Appendix I of RNTPC
Paper No. A/NE-HLH/68B

**APPLICATION FOR PERMISSION
UNDER SECTION 16 OF
THE TOWN PLANNING ORDINANCE
(CAP.131)**

**Proposed Temporary Open Storage and Warehouse (Storage Of Construction Machinery and Construction Materials) for a Period of 3 Years at Lots 171 (Part), 172 (Part), 176 (Part) and 177 (Part) in D.D. 87, Ta Kwu Ling, New Territories
(Planning Application No. A/NE-HLH/68)**

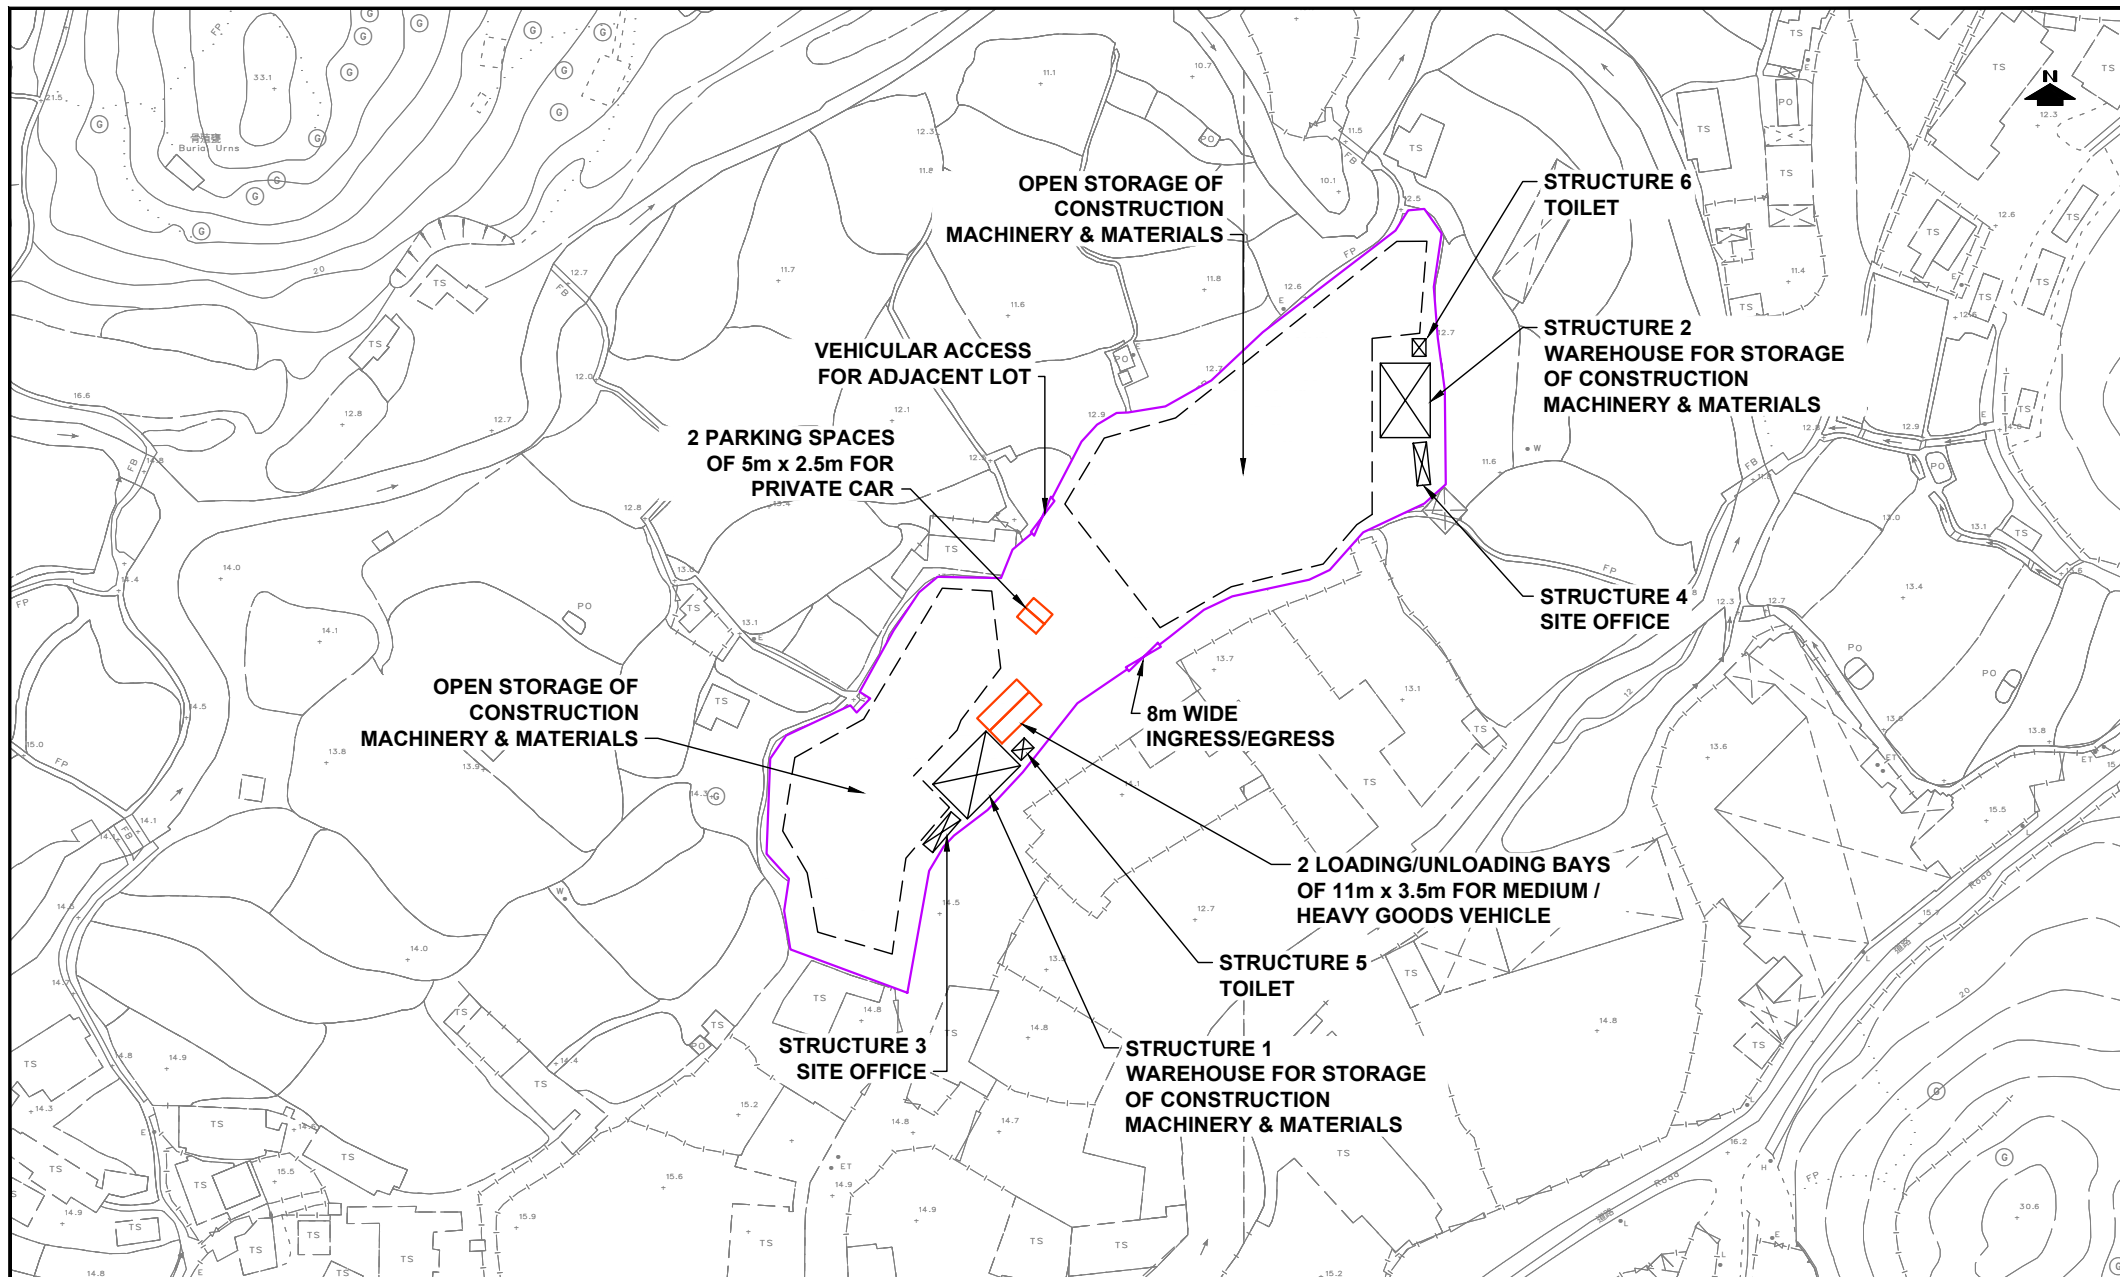
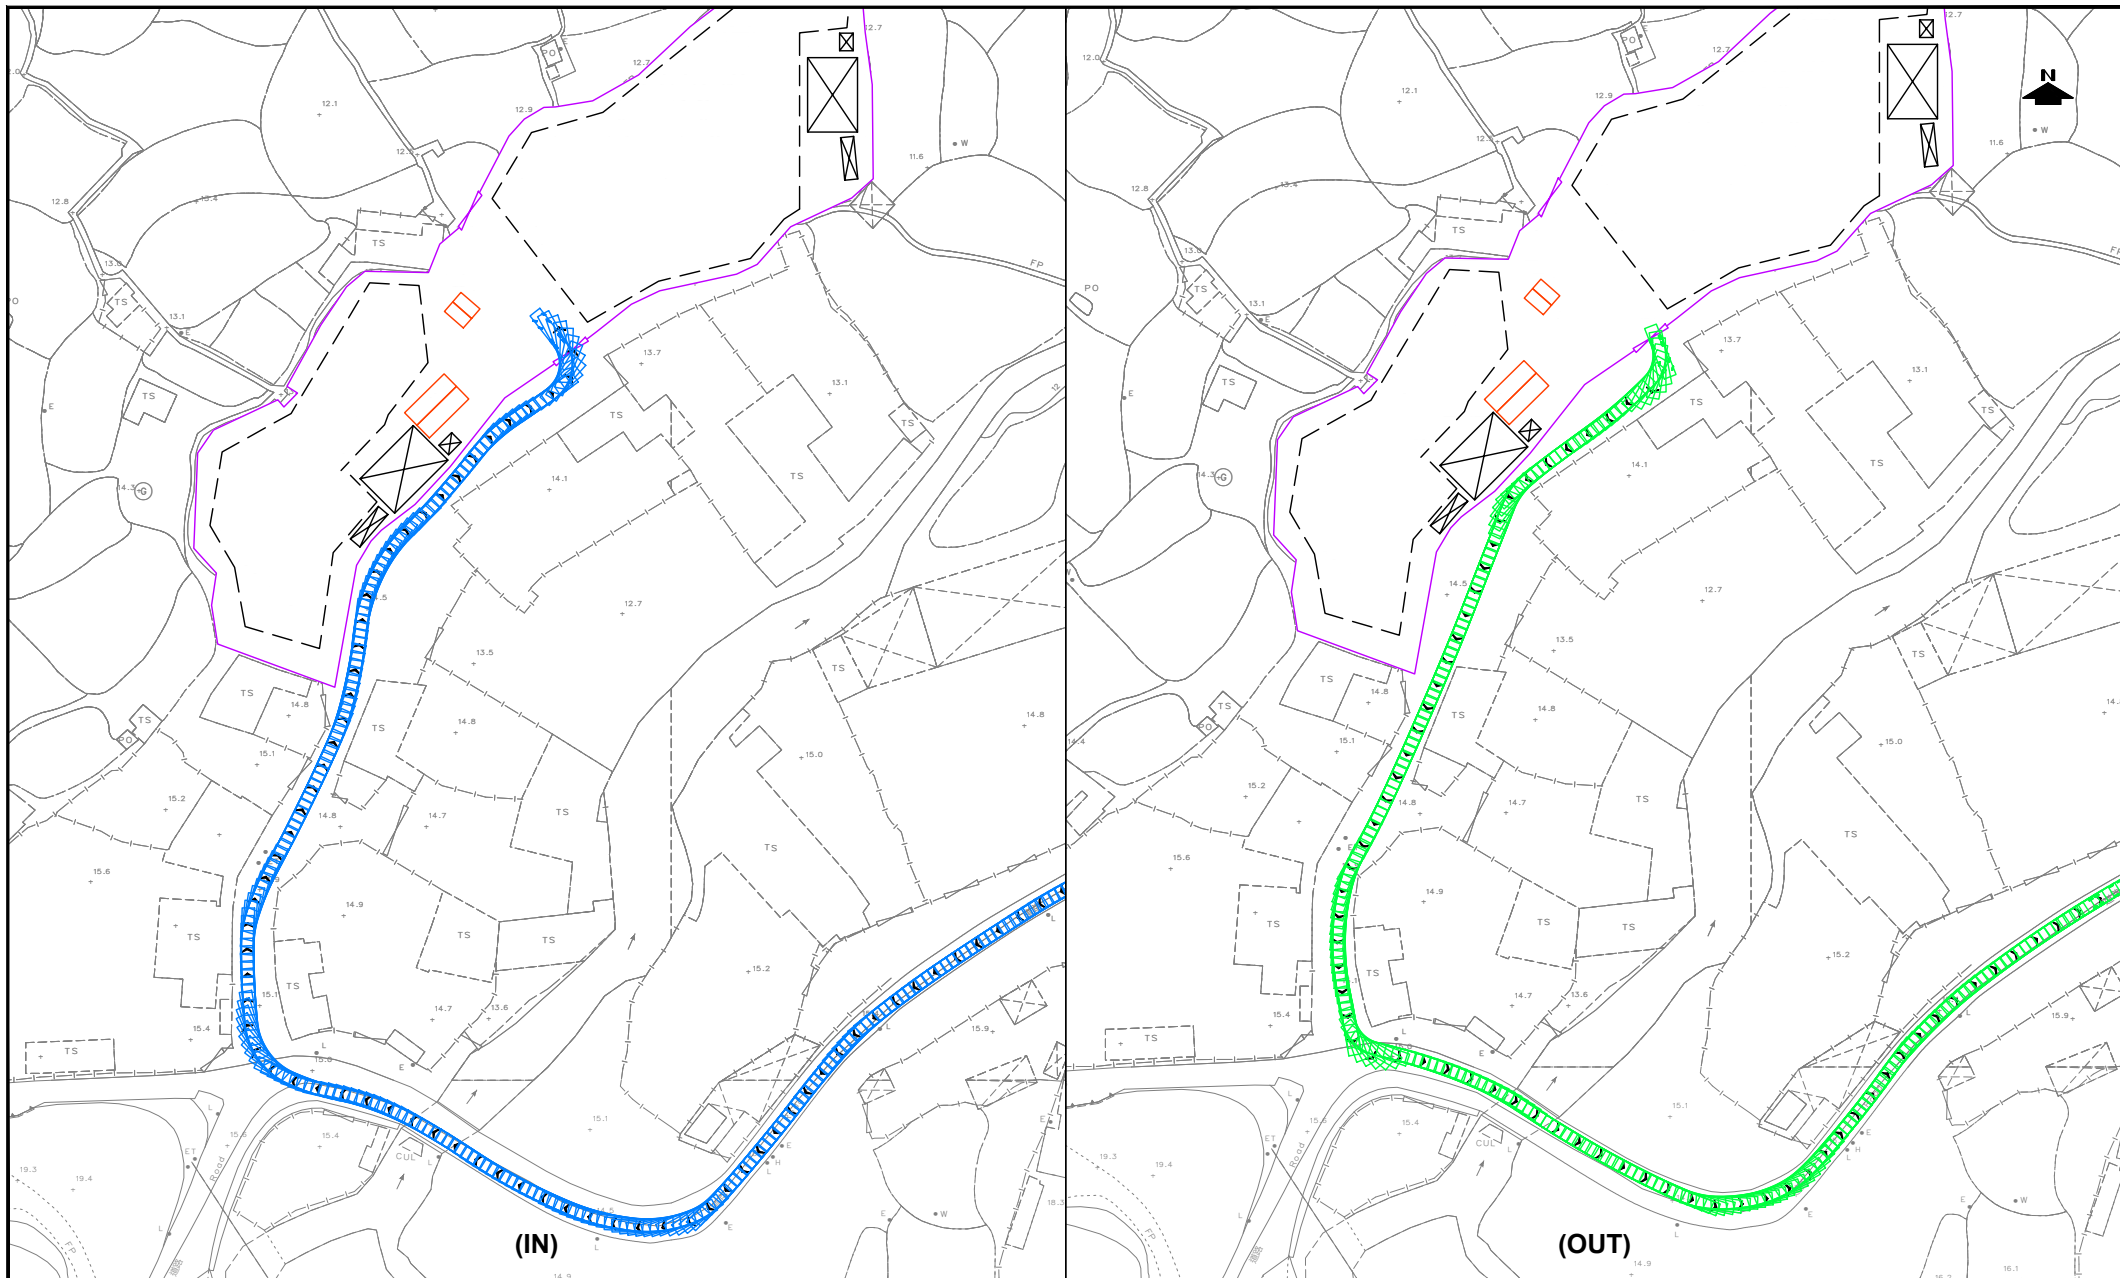
Comments	Responses
Comments from Transport Department	
(i) The applicant shall demonstrate the satisfactory maneuvering of the goods vehicles entering and existing the subject site, maneuvering within the subject site and into/out of the parking and loading/unloading spaces, preferably using the swept path analysis;	Please refer to Figure 1 for the proposed layout plan and Figures 2 – 3 for the swept path analysis results.
(ii) The applicant shall advise the management/control measures to be implemented to ensure no queuing of vehicles outside the subject site;	No drop bar will be provided at the Site entrance. During the operation hours, the gate will be kept open. Furthermore, a visit-by-appointment system will be implemented to control the number of vehicles visiting the Site to ensure no queuing of vehicles outside the Subject Site.
(iii) The applicant shall advise the provision and management of pedestrian facilities to ensure pedestrian safety;	Revolving lanterns will be provided at both sides of the vehicular access to warn the pedestrians when there is a vehicle exiting from the Subject Site. Appropriate footway is demarcated within the warehouse to ensure the pedestrian safety.

(iv) The applicant shall advise the measure in preventing illegal parking by visitors to the subject site; and	Please note that a visit-by-appointment system will be implemented to control the number of vehicles visiting the Site to ensure all visitors parked within the Site.

(v) The proposed vehicular access between Ping Che Road and the application site is not managed by TD. The applicant should seek comments from the responsible party.	Noted. Notices were being posted during the public consultation process and the applicant will resolve any objection received.

Our response to the comments of the Transport Department is shown in the attachment. Due to the submission of the swept path analysis, the location of the parking spaces and loading/unloading bay in the proposed layout plan have been updated.

Figure 4

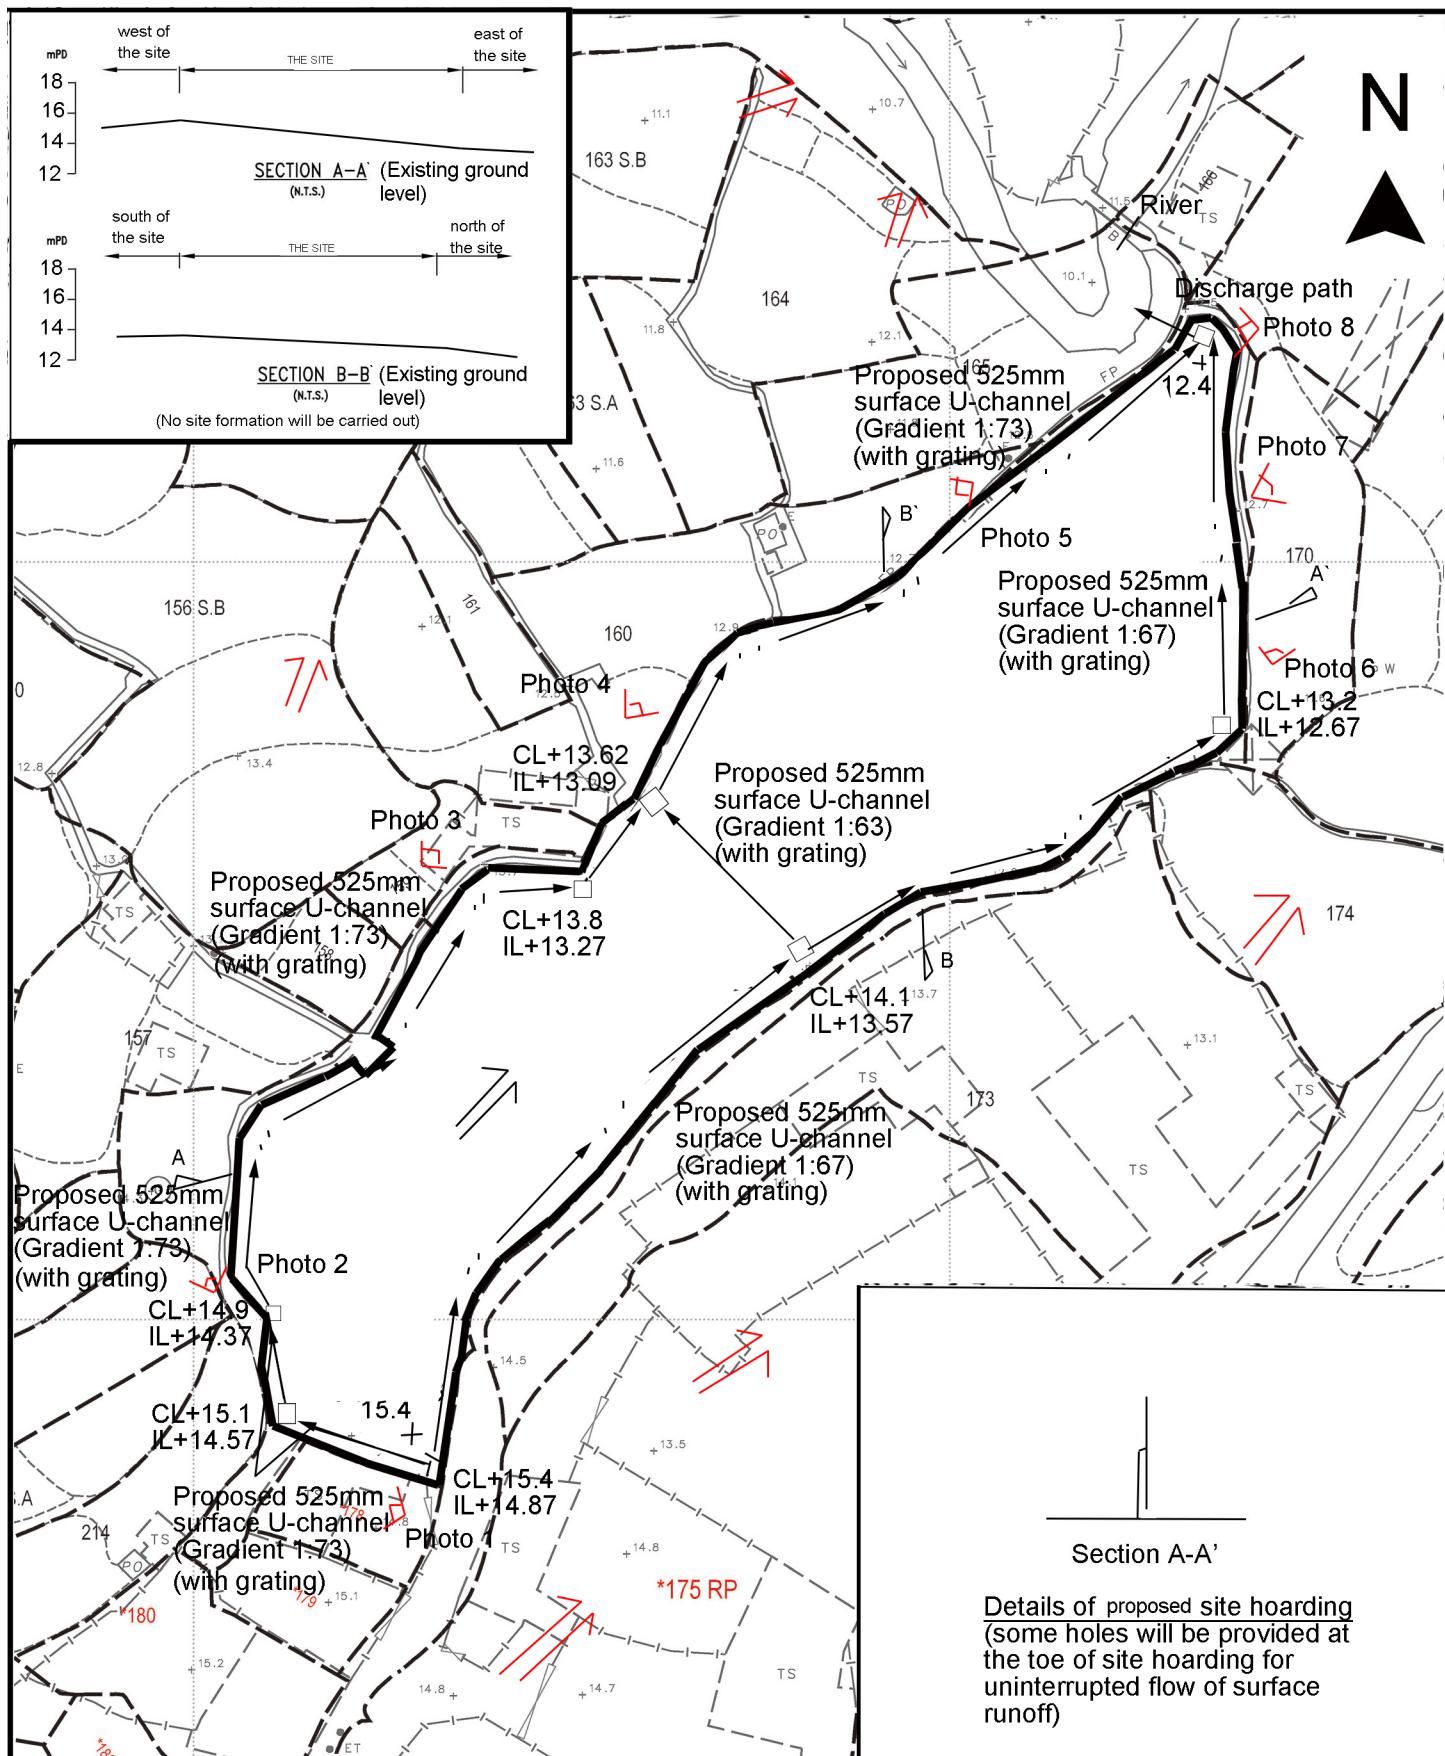
CE/MN, DSD's comments	Applicant's response
1. Catchpits with covers should be provided where there is a change of direction of the channel/drain. The details of the catchpit with covers shall be provided.	1. Catchpits with covers would be provided where there is a change of direction of the channel/drain. The details of the catchpit with covers is provided.

3. Please provide calculation to justify the adequacy of proposed drainage systems for the proposed development.	3. The proposed development is next to the river and the said river is the only outlet adjacent to the application site. In view of that no site formation will be carried out, the natural flow path will not be changed. Referring to the topography of the site, the stormwater at the site is flowing to the said river.

<p>4. Please clarify the outfall details and discharge path to the existing river.</p> <p>5. The applicant should check and ensure that the existing drainage downstream to which the proposed connection will be made have adequate capacity and satisfactory condition to cater for the additional discharge from the captioned site. He should also ensure that the flow from this site will not overload the existing drainage system.</p> <p>6. The applicant is reminded that where walls are erected or kerbs are laid along the boundary of the same, peripheral channels should be provided on both sides of the walls or kerbs, and/or adequate openings should be provided at the walls/kerbs to allow existing overland flow passing through the site to be intercepted by the drainage system of the site with details to be agreed by DSD, unless justified not necessary.</p> <p>7. Photos should be submitted clearly showing the current conditions of the area around the site, the existing drainage/flowpaths around the site, the proposed drainage from the site to the downstream existing watercourse and the existing watercourse. The locations of the camera and the direction of each photo should also be indicated on a plan.</p> <p>8. The applicant is reminded that all existing flow paths as well as the run-off falling onto and passing through the site should be intercepted and disposed of via proper discharge points. The applicant shall also ensure that no works, including any site formation works, shall be carried out as may adversely interfere with the free flow condition of the existing drains, channels and watercourses on or in the vicinity of the subject site any time during or after the works.</p>	<p>4. The outfall details and discharge path to the existing river is shown.</p> <p>5. Noted.</p> <p>6. Site hoarding will be provided surrounding the application site boundary. 100mm gap at the toe of the site hoarding will be given.</p> <p>7. Noted. Please see below for the photos and updated drainage plan for camera points.</p> <p>8. All existing flow paths as well as the run-off falling onto and passing through the site would be intercepted and disposed of via proper discharge points. No works, including any site formation works, would be carried out as may adversely interfere with the free flow condition of the existing drains, channels and watercourses on or in the vicinity of the subject site any time during or after the works.</p>

(b) Please provide calculation to justify the adequacy of using 525mm U-channel.	Please see the calculation below.
(c) Please clearly indicate the catchpit with sand trap in the drainage proposal.	Please see the updated drainage plan (Figure 4) attached in the following.

- 1.3.1 Subject to the calculations in 1.2 above, it is determined that proposed 525mm concrete surface U-channel along the site periphery is adequate to intercept storm water passing through and generated at the application site (**Figure 4**).

CE/MN, DSD's comments	Applicant's response
(a) Please provide photo at the discharge point and the downstream existing watercourse.	Noted. Please see attached photo in the following. The photo viewpoint is found in updated drainage plan in the attachment (Figure 4)

Figure 7

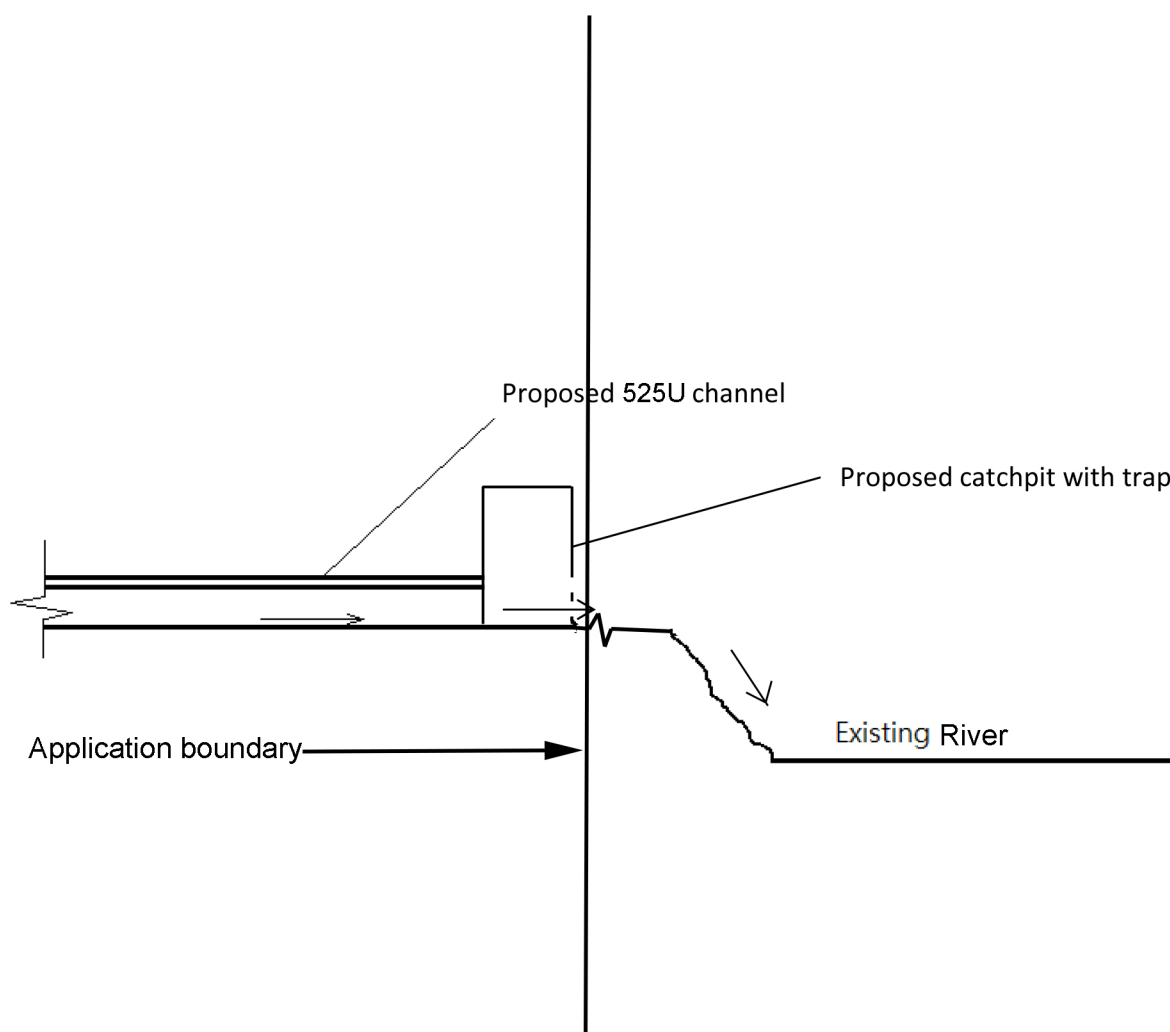
(d) Figure 7 refers. Please advise the clearance between the proposed catchpit and the existing river embankment. You are required to place all the proposed works at least 3m away from the top of the bank of the streamcourse. All the proposed works in the vicinity of the streamcourse should not create any adverse drainage impacts, both during and after construction. Proposed flooding mitigation measures if necessary shall be provided at the resources of the applicant to my satisfaction."	All proposed works would be at least 3m away from the top of the bank of the streamcourse. All the proposed works in the vicinity of the streamcourse would not create any adverse drainage impacts, both during and after construction. Proposed flooding mitigation measures if necessary shall be provided at the resources of the applicant to CE/MN, DSD's satisfaction
